**DISCLAIMER**  
 TO THE BEST OF OUR KNOWLEDGE, THE WALLACE GROUP, INC. HEREBY STATES THAT THIS PLAN IS AS-BUILT/RECORD DRAWINGS. THE INFORMATION PROVIDED IS BASED ON SURVEYING CONDUCTED AT THE SITE AND INFORMATION PROVIDED BY THE CONTRACTOR.

PLAZA AT ROCKWALL

**UTILITY PLAN F**

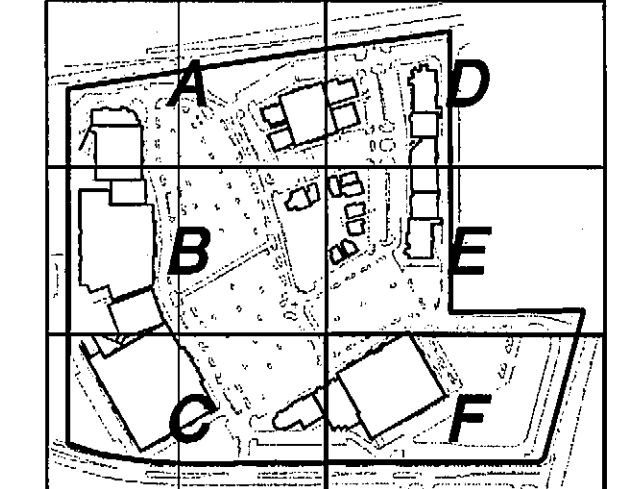
**REVISIONS**  
 - REVISED ALIGNMENT  
 - CLEANOUT  
 - 2" WATER SERVICE  
 - 2" VALVE

1 - 6" VALVE  
 1 - 2" VALVE

1 - 8" VALVE  
 1 - 6" FH

4 - 2" VALVES

- 2" IRRIGATION METER  
 - 2" VALVE

- 12"X8" TEE  
 - 12" VALVE

REV	DATE	BY	DESCRIPTION
3-19-07		MM	Removed and revised fire hydrant locations
2-19-07		R33	Revised utility service connections & removed Fire Hydrants
